KANE NSS.378 / NSS.378-1

ISSUE 7.1

BLOOR HOMES

DRAWING: JOIST SETTING OUT

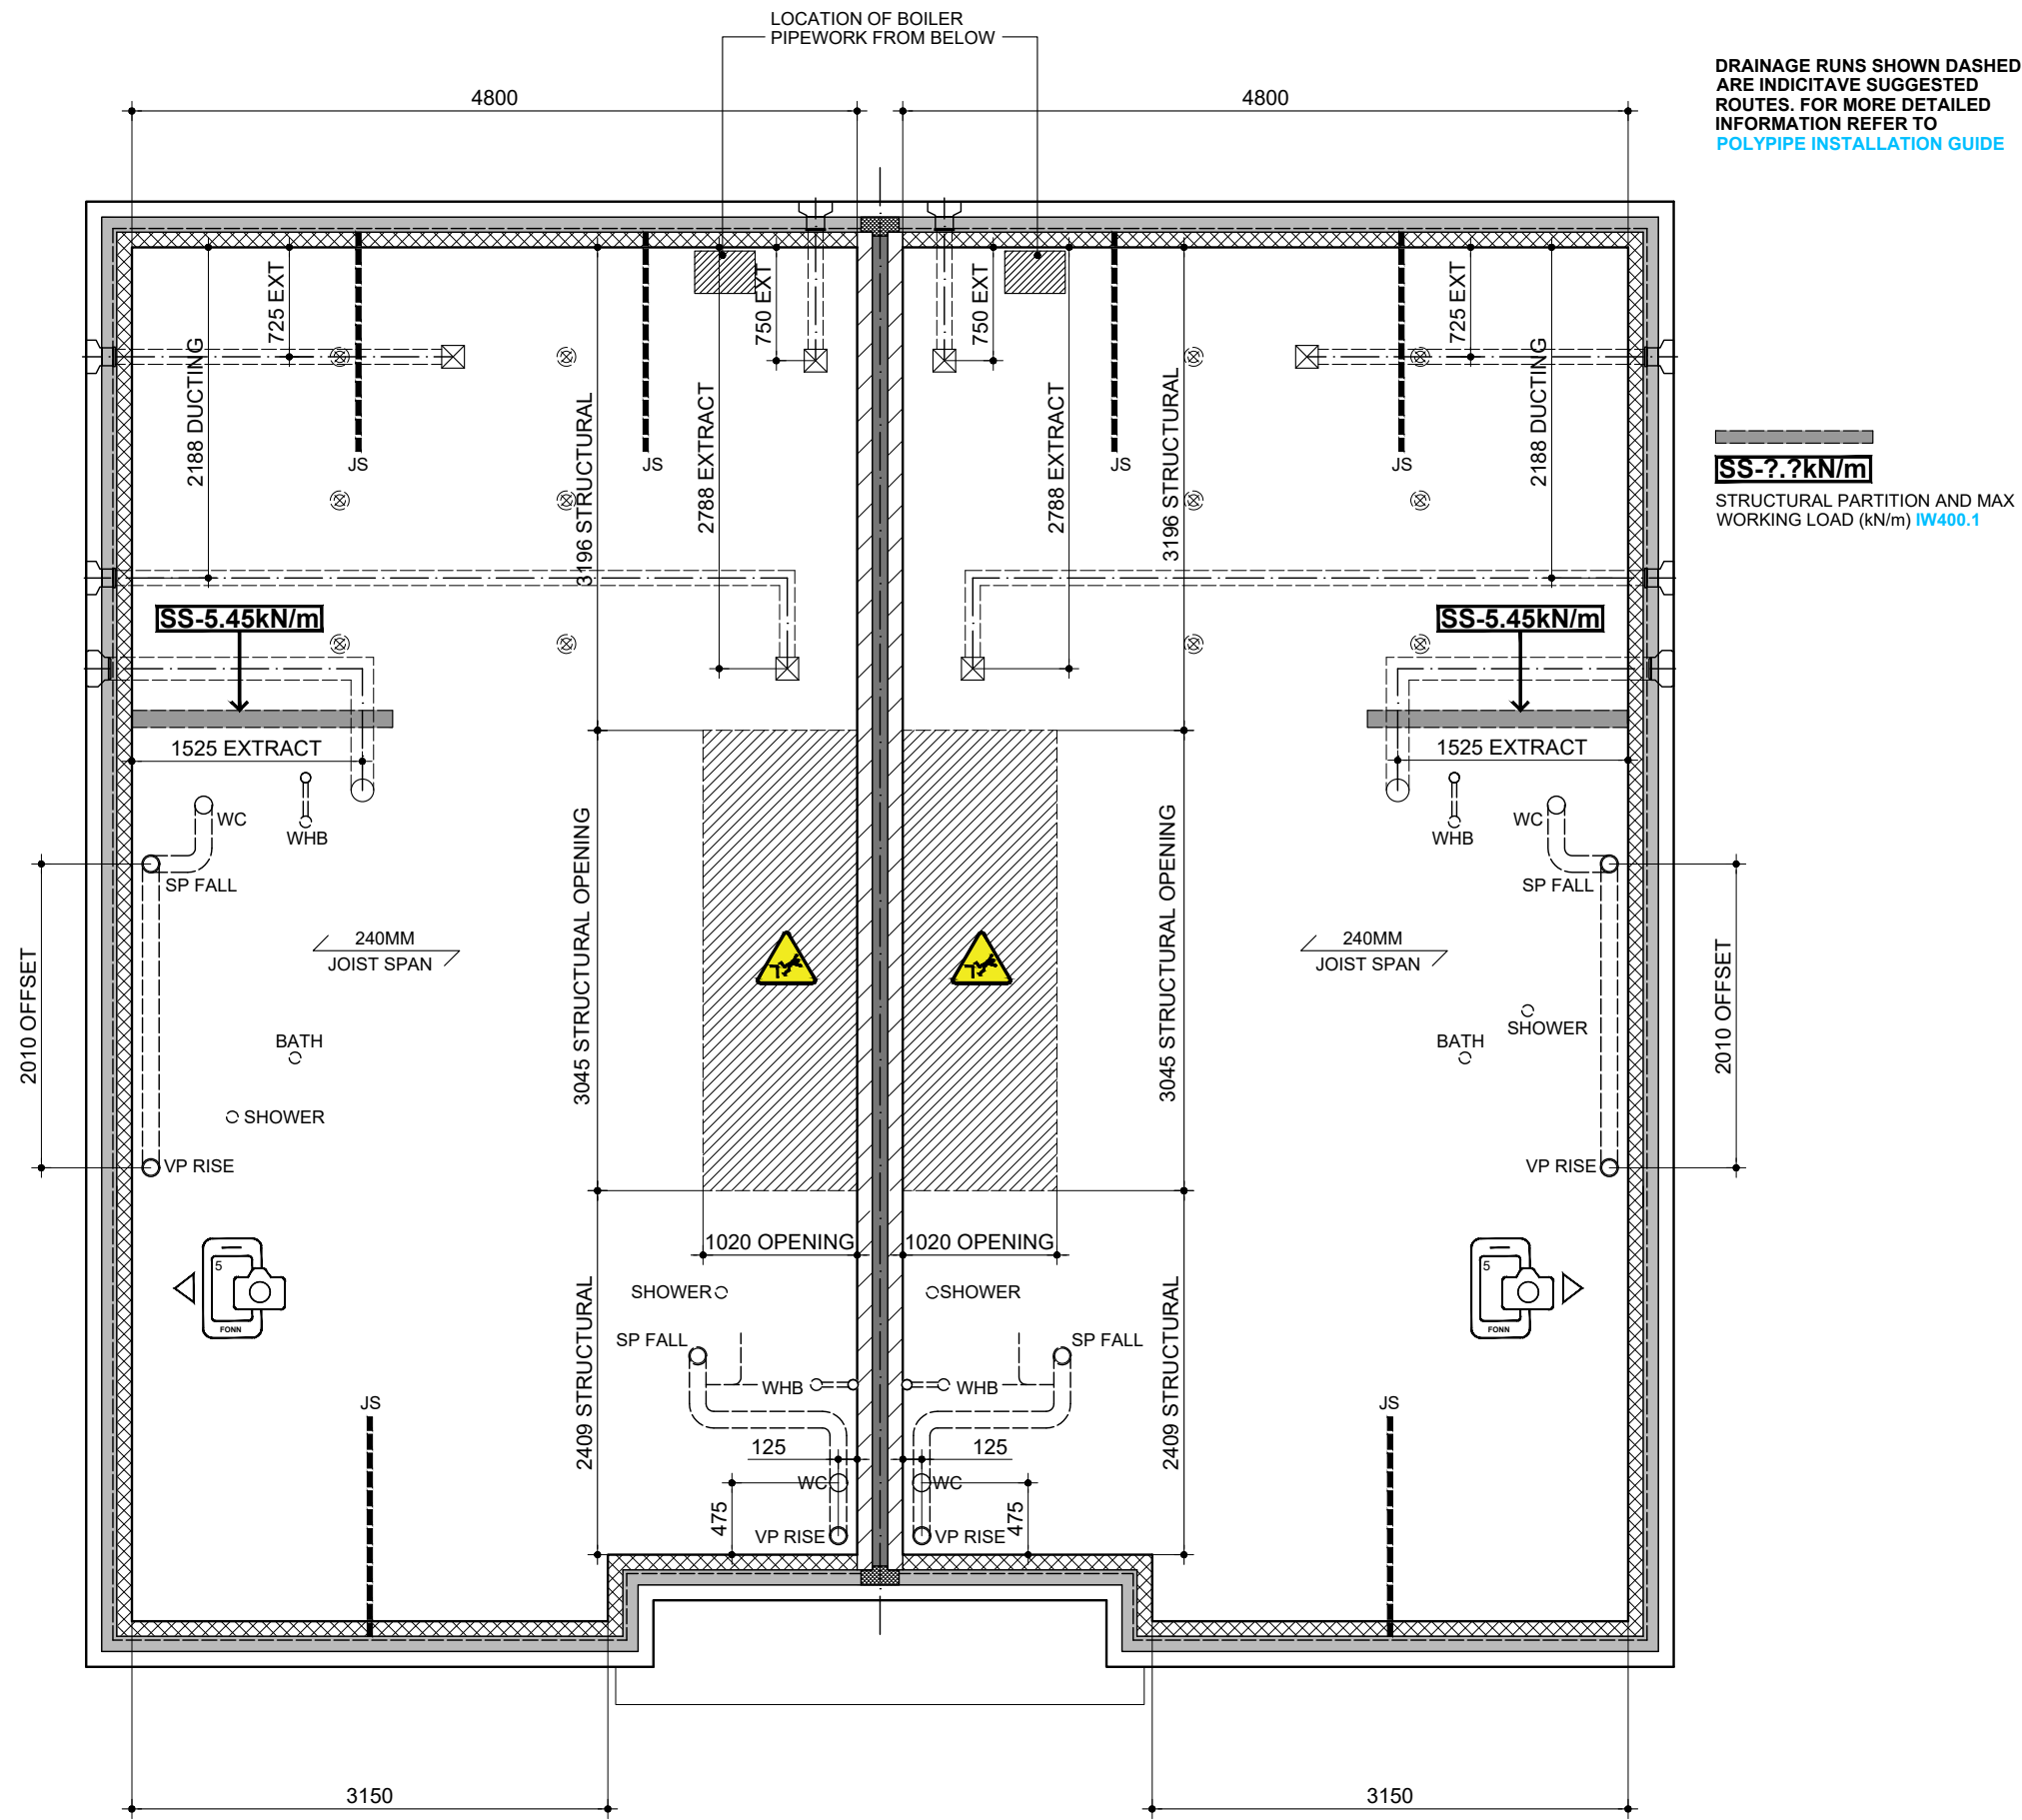
STRUCTURAL STUD LOADING
REVISED IN LINE WITH
STRUCTURAL CALCS.

DRAWING: TRUSS SETTING OUT

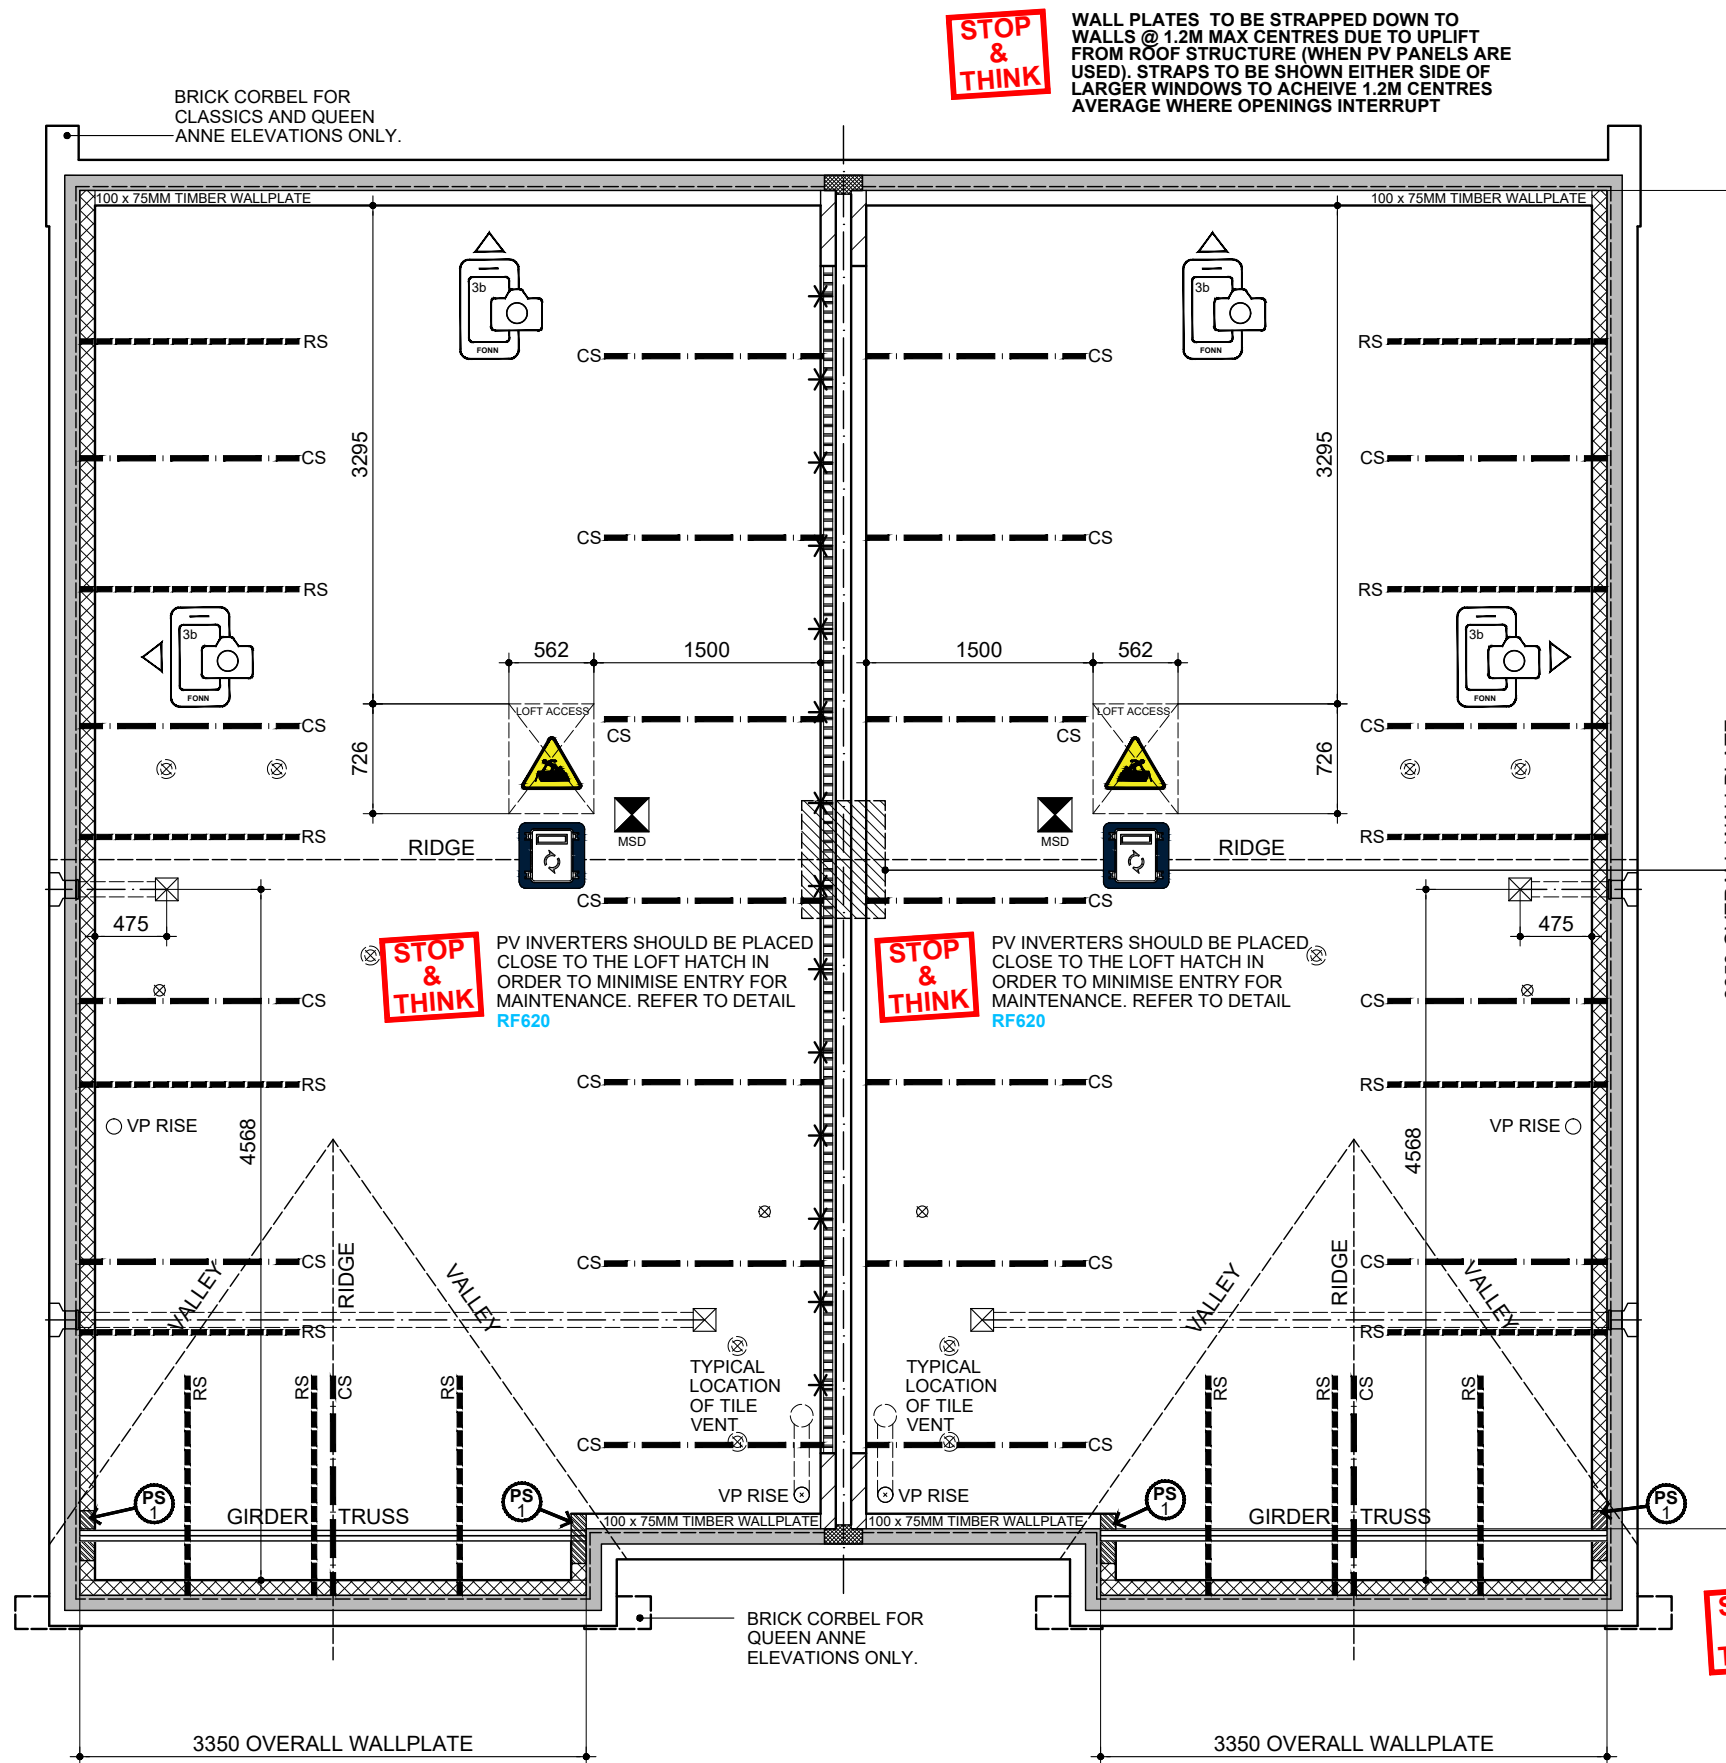
BATHROOM EXTRACT FAN
REVISED TO CEILING MOUNTED
IN LINE WITH FEEDBACK.

DRAWING: FF ELECTRICAL LAYOUT

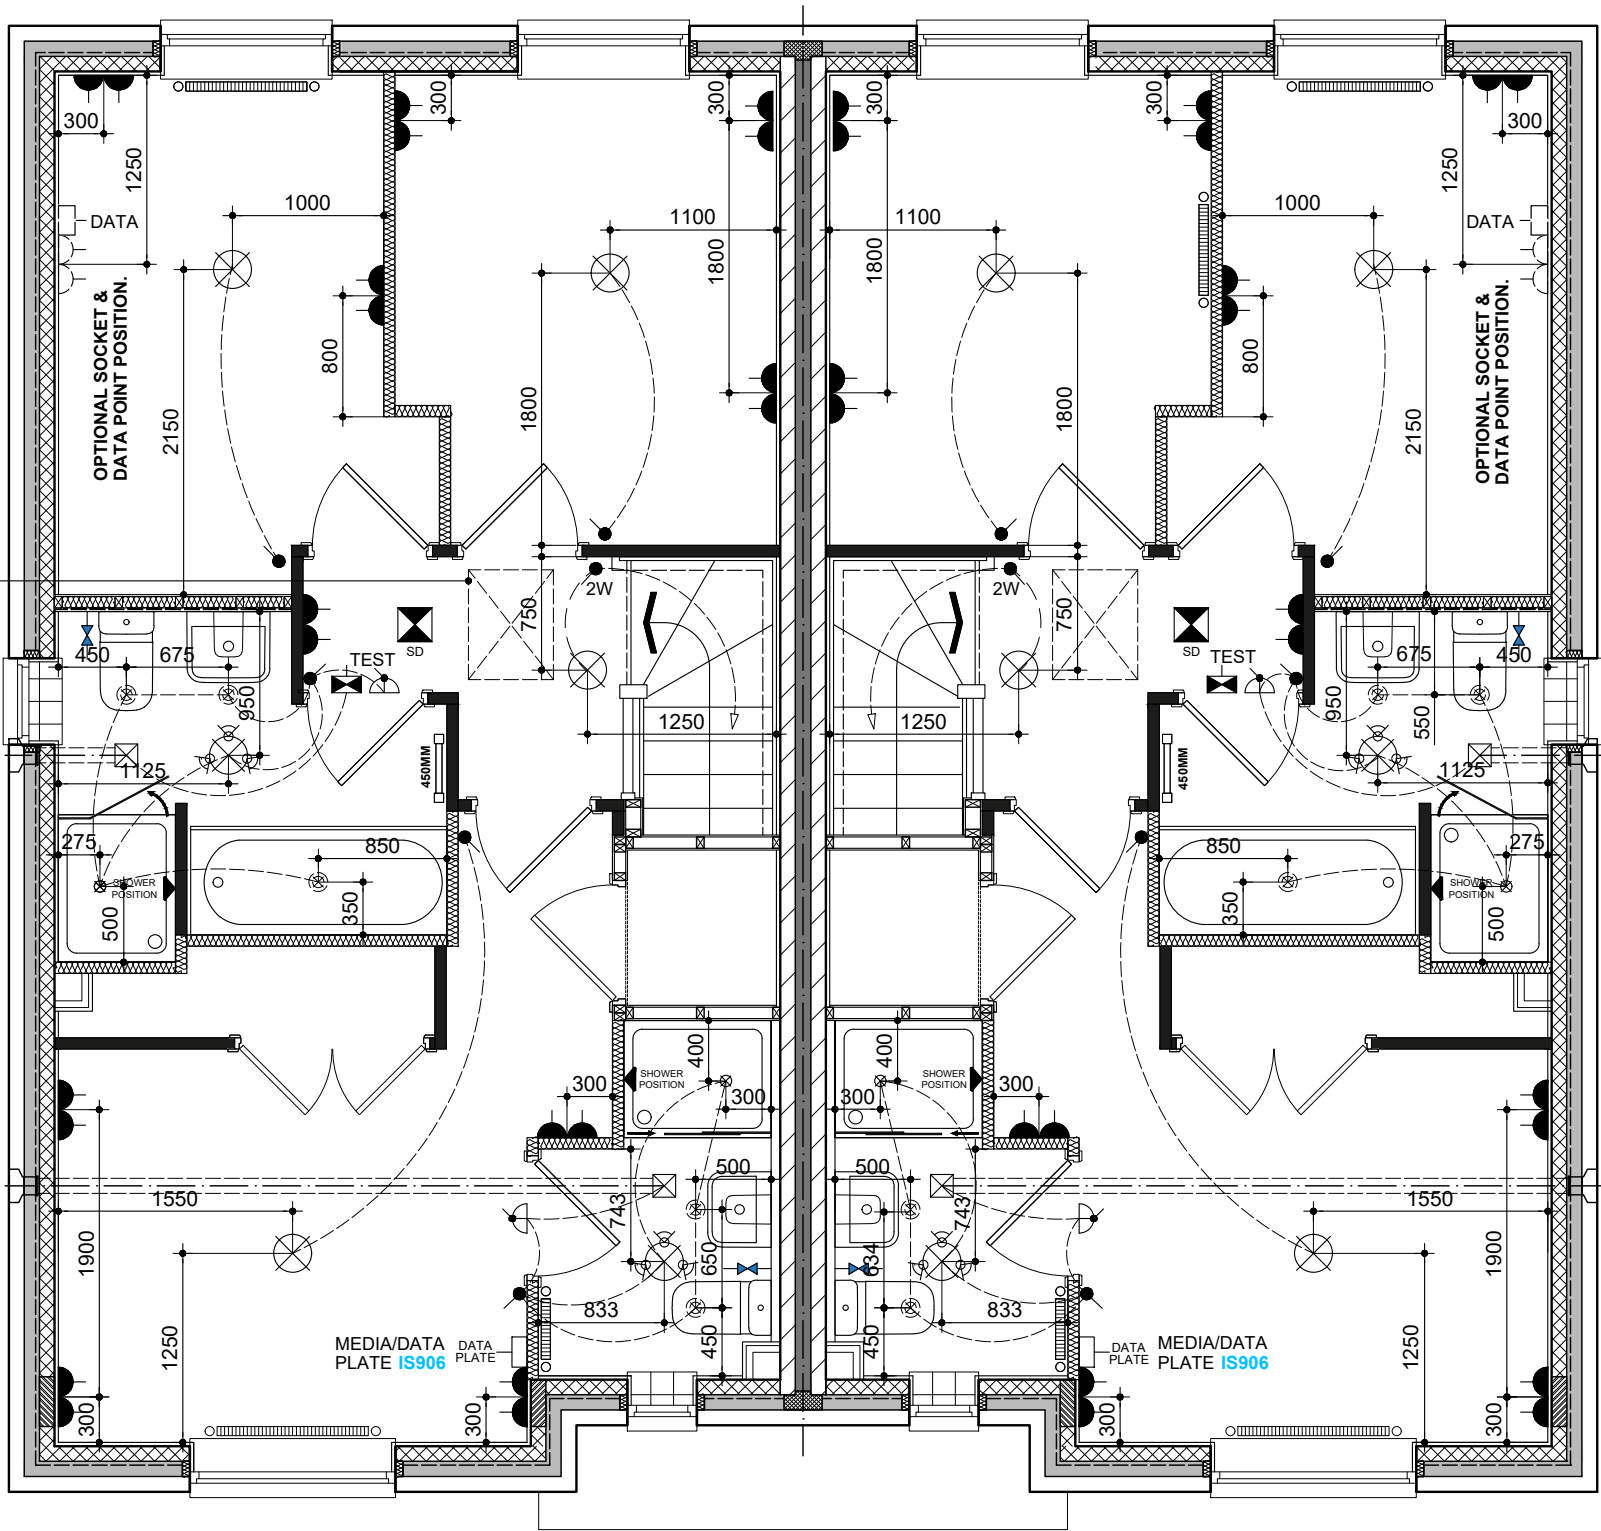
BATHROOM EXTRACT FAN REVISED TO CEILING MOUNTED IN LINE WITH FEEDBACK.
